PAINT BRUSH HILLS FILING 14 PRELIMINARY PLAN

FALCON, CO 12/30/2020 SECOND SUBMITTAL

Preliminary Plan Drawings_V2 planning only.pdf Markup Summary 1-29-2021

CS01 SHEET 1 OF 3

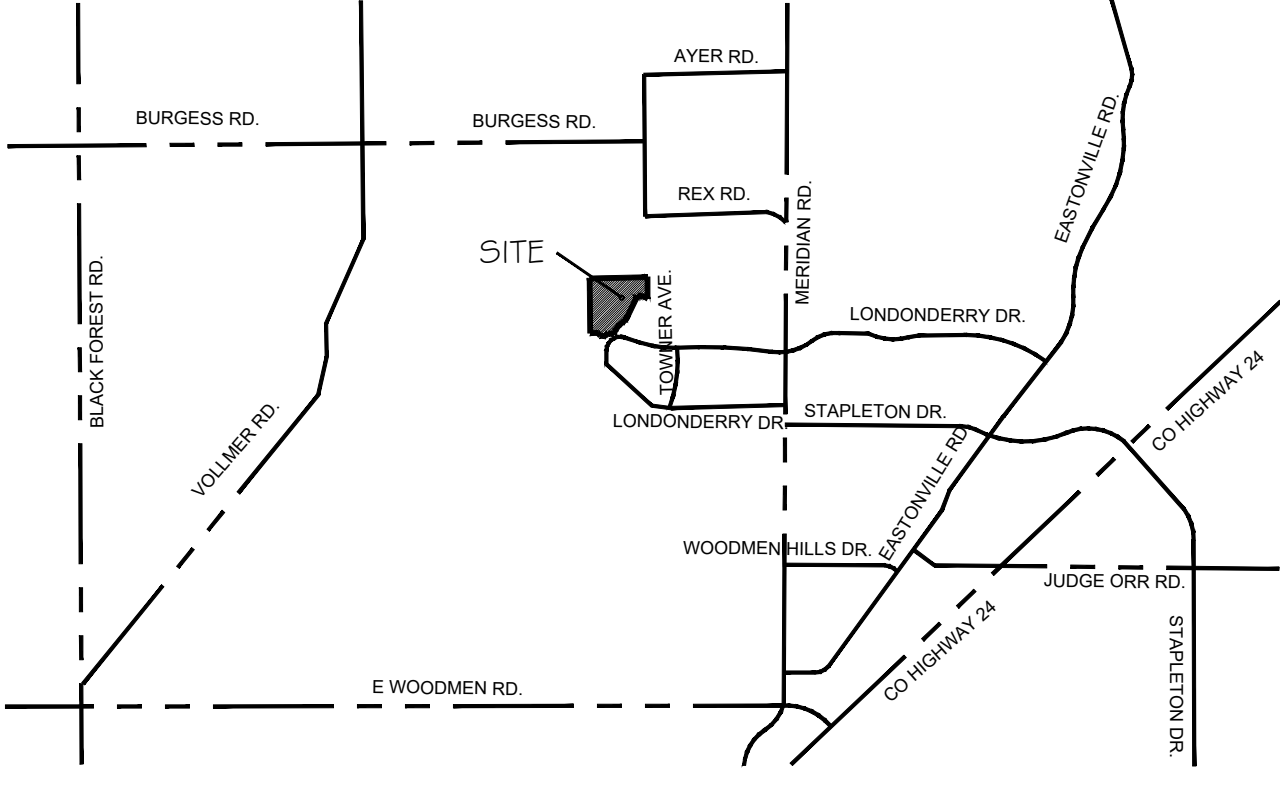
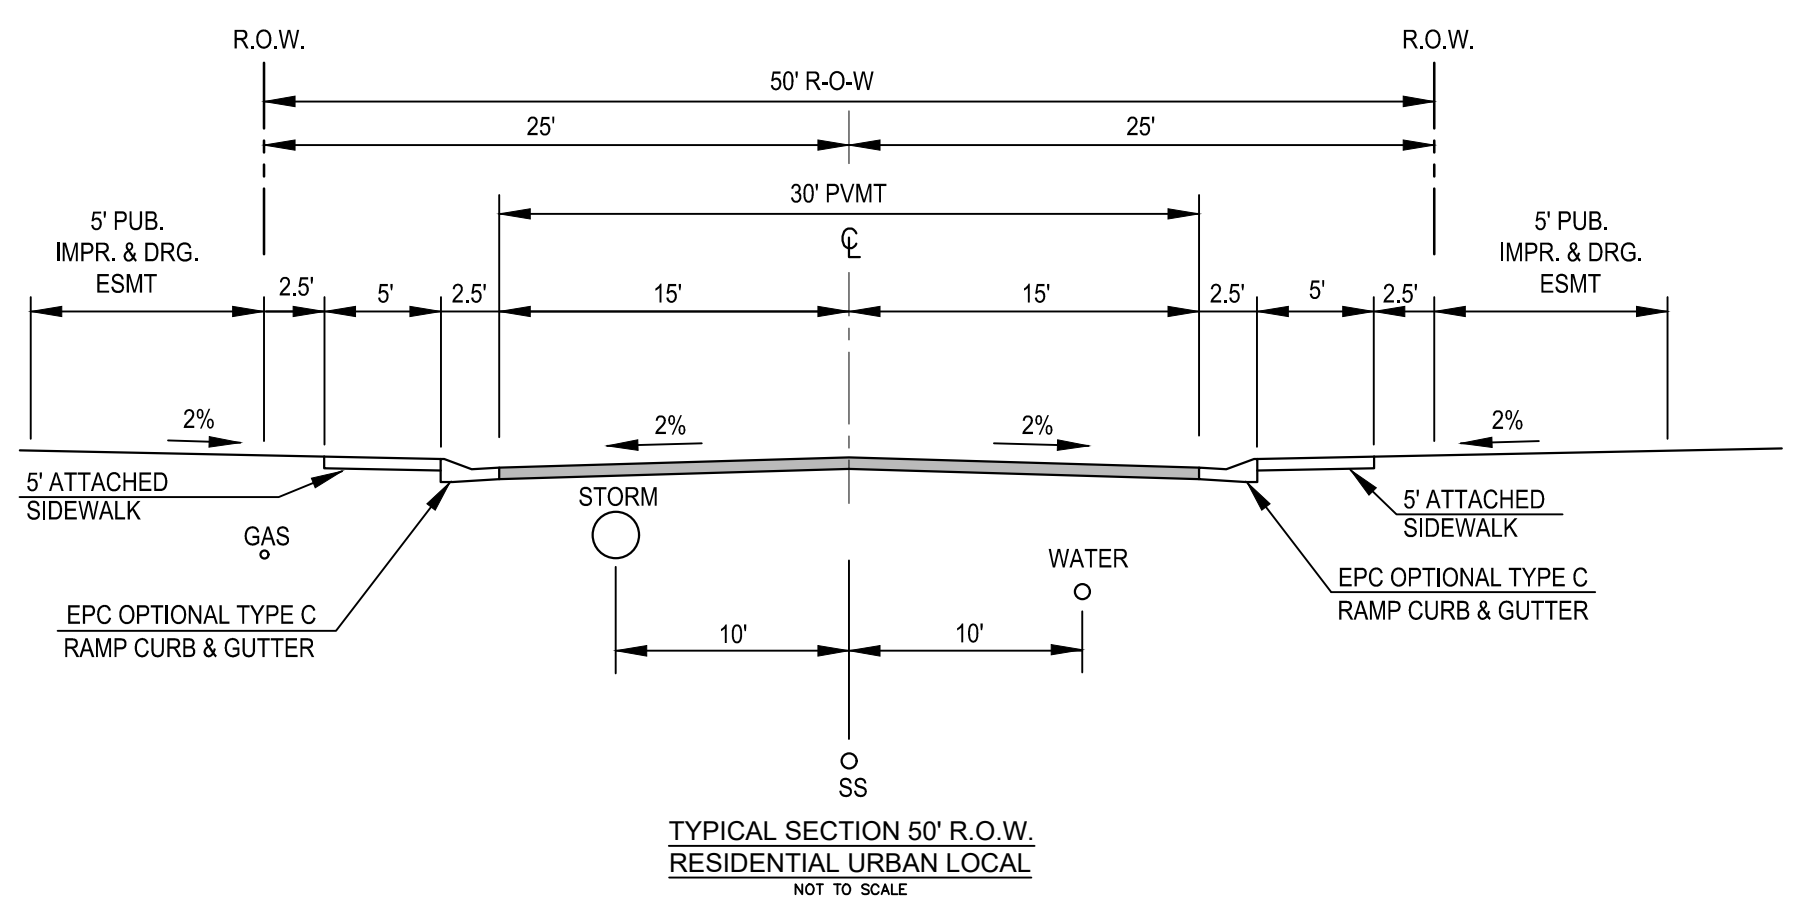
Based on CGS Comments (CGS has not provided a comment to the contrary with 2cd review please add notes unless a CGS comment letter modifying CGS comments is obtained): Engineered site plans to include groundwater monitoring may be required for the following lots if basements are proposed: grading and a seasonal groundwater monitoring program. Lots 6, 7, 8, 9, 10, 11, 12, 13, 26, 54, 55, 56, 91, 92, 93, 99, 100, 101, 102, 103, 104, 105, 108, 109, 110, 118, 119, 121, 122, 123, 124, 126, 127, 128, 156, 157, 158, 159, 160, 165, 166, 167, 168, 171, 172, 173, 174, 175, 176, 177, 178, 179, 183, 184, 185, 186, 187, 188, 189, 190, 191, 192, 193, 195, 196, 197, 198, 199, 200, 201, 206, 207, 208, 215, 216, 224. Identified geologic hazards include shallow bedrock, erosion, expansive soils, issues related to seasonally shallow groundwater, frost heave related to shallow groundwater, artificial fill, potential groundwater seepage, shallow bedrock, perched groundwater (flowing on top of bedrock and within sandstone lenses). Areas of seasonal shallow groundwater and the potential for shallow groundwater have been mapped and Entech has recommended that basements not be allowed in these areas and/or site grading raise the areas impacted. In addition, RMG states that an existing drainage has been infilled without records indicating if drain recommendations were followed. As infilled drainages can become conduits for groundwater CGS recommends that the lots in the area of the infilled drainage (map unit valley infill "V") also exclude basements or below grade areas.

These are the identified constraints:

25' Region Trail Easement

Address and add a corresponding note: Are under drains and Perimeter drains to be utilized to mitigate in addition to the basement limitations? Who will be maintaining the under drains/perimeter drains

please call out the lots specifically that have non-standard setbacks so that they are easily identified by Front counter staff...in a note on sheet 1 of prelim and plat.

SP01

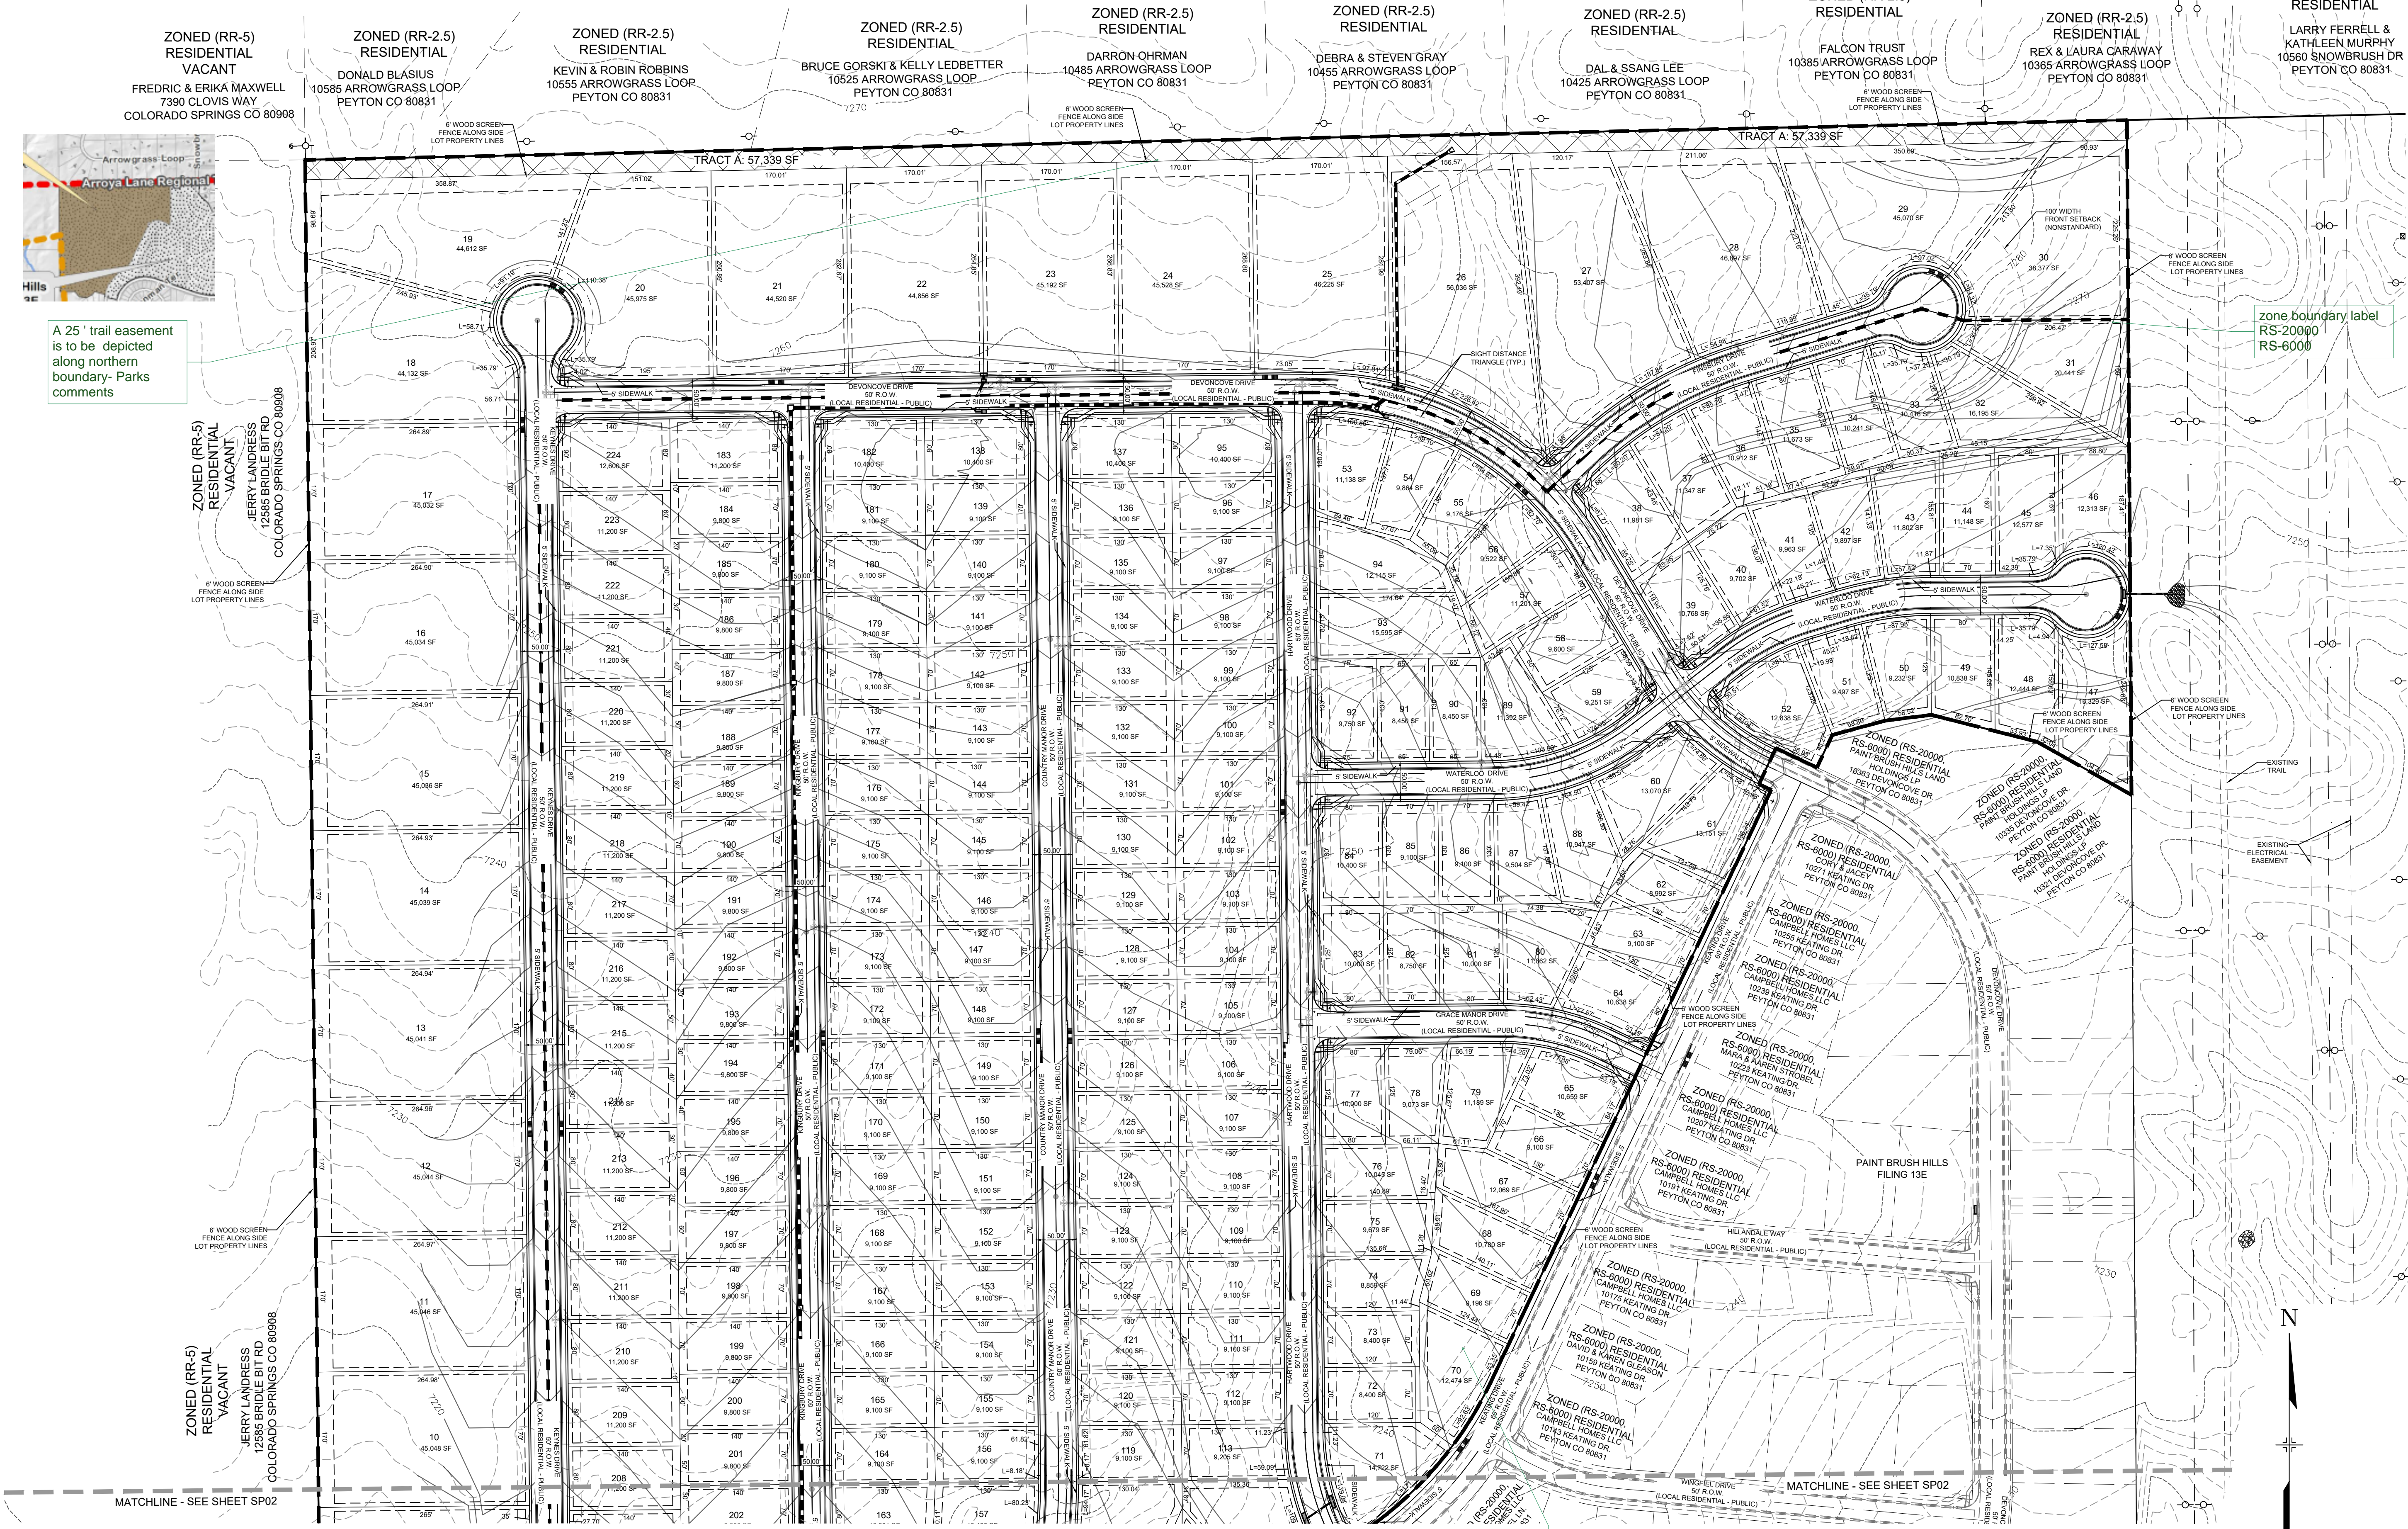
A 25' trail easement is to be depicted along northern boundary- Parks comments

zone boundary label
 RS-20000
 RS-6000

this appears to not a build-able lot- REAR and Front setbacks are 25 feet, side is 5 feet; merge with another lot(s) or make a tract
